Access Compliance Report

Public Rights-of-Way

Intersection ID: 45756	Main Street: CHRISTENBURY_RD	Cross Street: GRANDEUR_RD	Location: SW
ADA ID: D7BB9C1453BF	Ramp Type: PerpDiag	Initial Pass/Fail: Fail	Overall Compliance: No
		Severity Score: 10

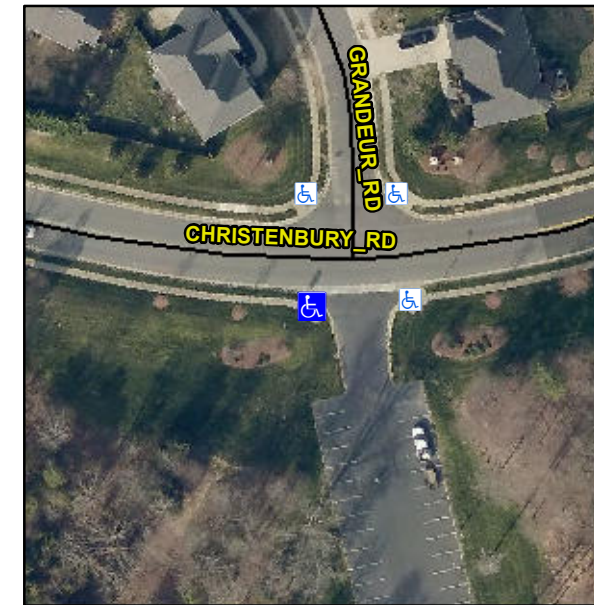
R304.5.1, R304.5.3

Compliance	Description	Data	Compliance	Description	Data
N/A	Ramp Length (in)	47.0	Yes	Ramp Slope (%)	5.7
No	Ramp Width (in)	47.0	No	Ramp XSlope (%)	3.1
N/A	Flare Type LT	N/A	N/A	Flare Type RT	N/A
N/A	Flare Slope LT (%)	N/A	N/A	Flare Slope RT (%)	N/A
N/A	Flare Traversable LT?	N/A	N/A	Flare Traversable RT?	N/A
N/A	Landing Length (in)	N/A	N/A	DWS Provided?	N/A
N/A	Landing Width (in)	N/A	N/A	DWS Contrast?	N/A
N/A	Landing Slope (%)	N/A	N/A	DWS Length (in)	N/A
N/A	Landing X Slope (%)	N/A	N/A	DWS Full Width?	N/A
N/A	Landing Curb? (Y/N)	N/A	N/A	DWS Offset (in)	N/A
N/A	Shared Landing?	N/A			
N/A	Gutter Ponding?	N/A	N/A	Gutter Slope (%)	N/A
N/A	Gutter Lip Ht (in)	N/A	N/A	Gutter X Slope (%)	N/A
N/A	Painted X Walk1?	No	N/A	Painted X Walk2?	No
	X Walk 1 Direction	To E		X Walk 2 Direction	To N
N/A	X Walk 1 Width (in)	N/A	N/A	X Walk 2 Width (in)	N/A
	X Walk 1 Slope (%)	2.2		X Walk 2 Slope (%)	2.7
	X Walk 1 X Slope (%)	4.6		X Walk 2 X Slope (%)	0.3

Remove & Replace Curb Ramp With Two New Directional Ramps or Equivalent.
